N60 Breaffy Active Travel and Safety Measures Scheme

Stage 1 Road Safety Audit Report

Issue 1 - August 2022

Document No: N60BA-ROD-GEN-SW_AE-RP-CH-301001 P02

Figure 6.21: Proposed Crossing Point at One-Way Access to Breaffy Village

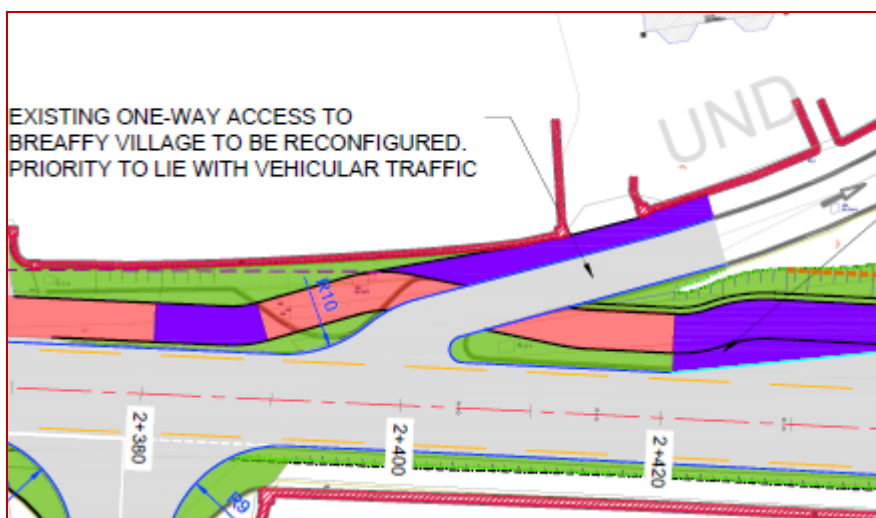
Drawing No. N60BA-ROD-HWY-SW_AE-DR-CH-30054 Rev.P01 indicates that a new crossing point is located at the existing one-way access road to Breaffy Village. It is unclear if kerbing is provided at this location. Without the provision of kerbing, drivers turning left off the N60 could over-run the grass verge to smoothen the turn and thus maintain higher speed. It is noted that tactile paving is not provided at the crossing which could increase the likelihood of visually impaired pedestrians unintentionally entering the carriageway and colliding with vehicles.

Care should be taken during the development of the scheme to ensure that kerbing is provided to clearly define the junction and tactile paving should be provided to cater for the requirements of visually impaired pedestrians.

6.21	YES	YES - Kerbing and tactile paving have been designed at this location but are not shown on the general layout drawings submitted for stage 1 audit.

Figure 6.22: Shared Facility Crossing Point at Breaffy Village

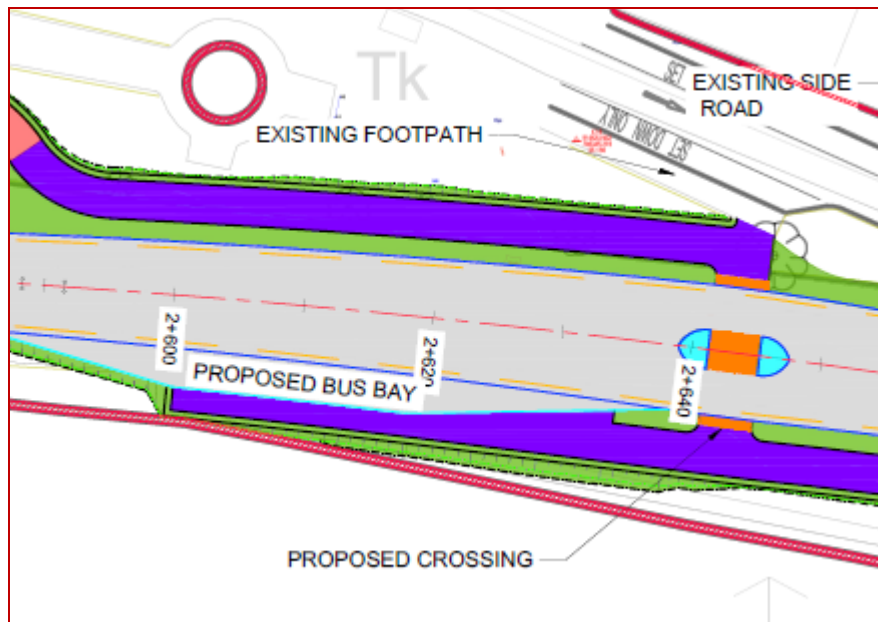
It is unclear whether signs or road markings will be provided to inform pedestrians / cyclists of the presence of the crossing point at Ch.2+640 and that the shared facility switches to the opposite side of the road. This is particularly relevant for pedestrians travelling westbound on the southern side of the N60 where the shared facility appears to continue straight for a distance, leading to the proposed bus bay.

Care should be taken during the development of the design to ensure that pedestrians / cyclists are informed that the shared facility switches to the opposite side of the N60 and are directed to the crossing point with provision of signs or road markings.

6.22	Yes	Yes - Signage and marking to be addresses

Figure 6.23: Access to Premises on Eastern Side of Priority Junction at the L5783

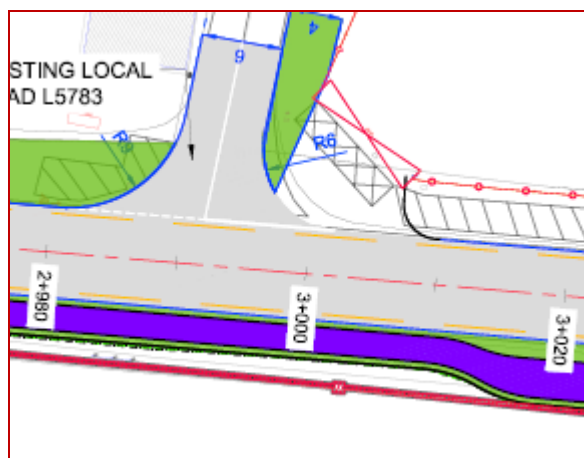
A priority junction is located between the N60 / Local Road L5783 at Ch.3+000m. An existing private premises is located on the east side of the L5783 facing onto the N60 but directly adjacent to the junction. It is unclear if access to the premises is provided at the corner of the junction. This could increase the likelihood of a vehicle accessing and egressing the premises colliding with a vehicle on the public road.

Care should be taken during the development of the scheme to ensure that access is not permitted to the premises via the corner of the priority junction. A single defined access to the premises should be provided which should be located away from the priority junction to enable clear demarcation between the direct access to the premises and the priority junction.

at Detail Design		
6.23	Yes	No	This existing access is necessary for the operation of the premises. The proposed kerbed islands to the west of the junction are intended to prevent entry across the corner of the junction and force a slow deliberate turning manoeuvre into the premises. The access arrangements will be reviewed in discussion with the landowner and the local authority at the detailed design stage to ensure traffic cannot cut across the corner of the priority junction and increase the separation between the local road and the access.	Yes
